# HOLDOVER

## **HIGHLAND PARK SUBDIVISION, RESUBDIVISION OF LOTS 21 & A PORTION OF LOT 22**

APPLICATION NUMBER Holdover DATE August 7, 2003

# HIGHLAND PARK SUBDIVISION, BLOCK 5, RESUBDIVISION OF LOTS 21 & A PORTION OF LOT 22

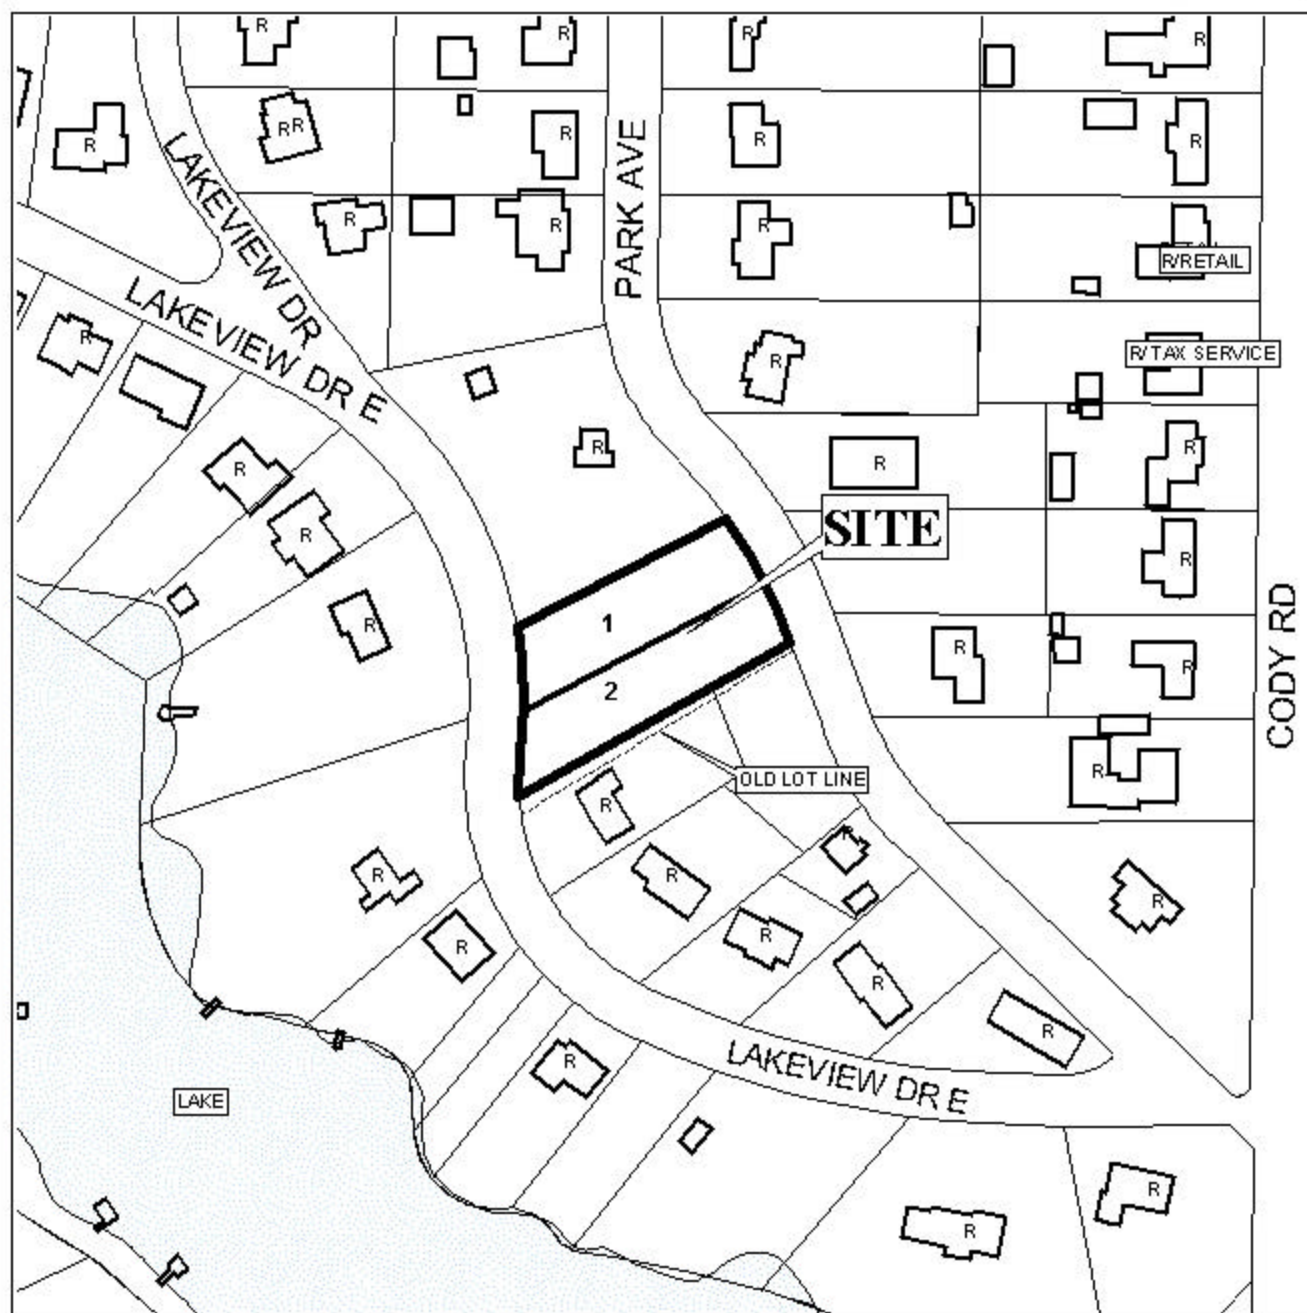
As illustrated on the site plan, the site will have frontage along two streets and there is a note on the final plat stating that the site is denied access to Park Avenue South.

As illustrated on the plat, the balance of Lot 22 is not included in the subdivision. The balance of Lot 22 should be included in the subdivision or the submission of documentation to establish the balance of Lot 22 as a legal lot of record prior to 1984 should be required.

This site is located in the County, thus a note should be placed on the final plat stating that any lots which are developed commercially and adjoin residentially developed property must provide a buffer in compliance with Section V.A.7., of the Subdivision Regulations.

Based upon the preceding, this application is recommended for holdover to allow the applicant to include the balance of the property in the subdivision with the additional notification, or to submit documentation to establish the balance of the property as a legal lot of record prior to 1952. This information should be submitted by July 14<sup>th</sup> to be considered at the Commission's July 24<sup>th</sup> meeting.

*August 7<sup>th</sup> meeting: At the time of mailout, no additional documentation had been submitted. Based upon the preceding the application is recommended for denial for the following reason: 1) the site does not include the overall property from which the lots are being taken (the balance of Lot 22).*
